AERONAUTICAL CHARTING FORUM
Instrument Procedures Group
April 29-30, 2002
HISTORY RECORD

FAA Control # 02-01-241

Subject: Non-radar Level and Climbing Holding Patterns

KAILUA-KONA, HAWAII
ILS DME Rwy 17

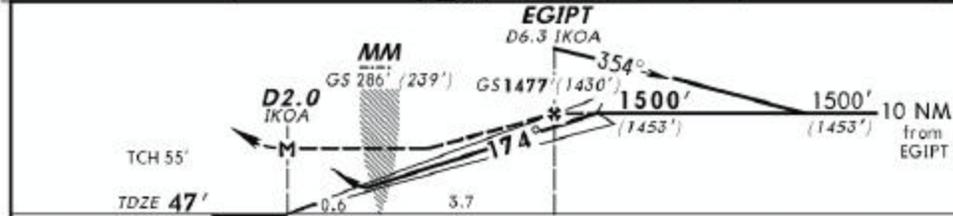
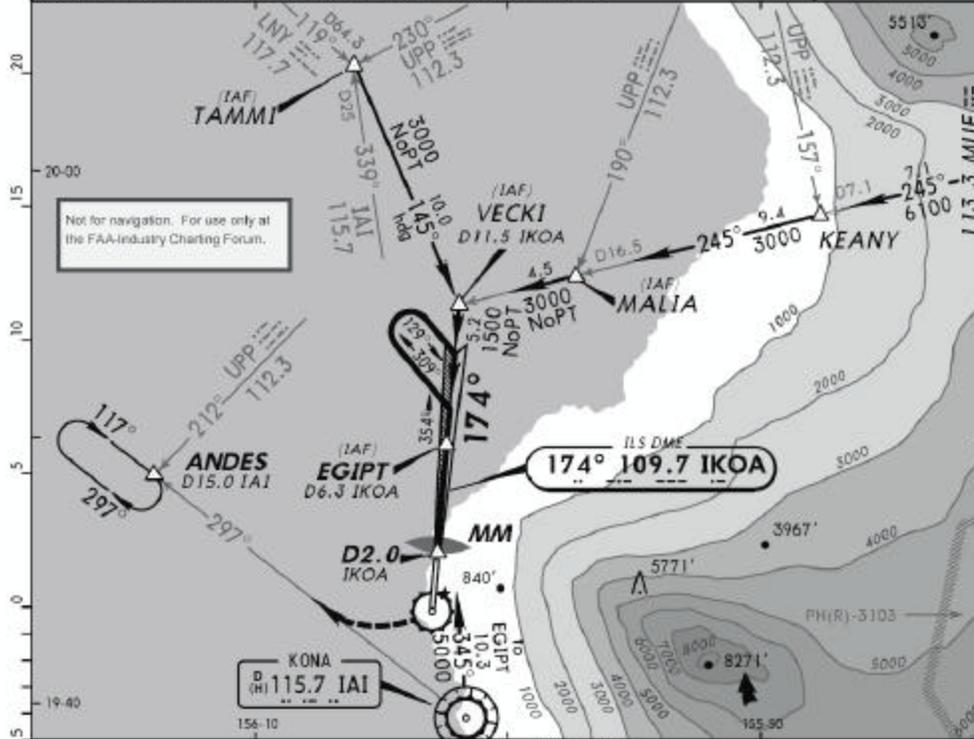
Background/Discussion: FAA holding pattern criteria and policies provide for 310-knot climb-in-hold (CIH) holding patterns for missed approach procedures used by jet airplanes where a 40:1 surface is penetrated in accordance with the criteria contained in 8260.3B, Paragraph 293b. Pilots have no way of knowing, however, which CIH patterns have been evaluated for CIH. Also, there are situations where a jet airplane CIH pattern does not trigger the provisions of 8260.3B, Paragraph 293b, so the pattern size used often provides for a maximum of 200 knots even though a modified CIH may be required. An example is attached, for the ILS 17 at Kona, Hawaii, (illustration attached) where the missed approach holding pattern is 40:1-free, and the holding altitude is 1,500 feet. But, a CIH to at least 5,000 is required to return to the approach procedure. Pilots have no way of determining what the maximum design speed is for CIH in any holding pattern. 200 knots is an inadequate speed for a transport jet airplane to climb in the Kona pattern, although 310 knots would be excessive.

Recommendation: CIH patterns such as in the Kona ILS 17 example, and all patterns used by jet airplanes where CIH is required, should be evaluated for 265 knots where 310-knot CIH patterns are not required. This requirement should extend to holding patterns for both missed approaches and DPs. Further, it should be made clear that the 310-knot CIH criteria apply to DP holding patterns where a Paragraph 293b evaluation finds 40:1 penetrations. Pilots should be informed, both by AIM reference material, and chart code, which patterns are authorized for 265-knot CIH and which are authorized for 310-knot CIH.
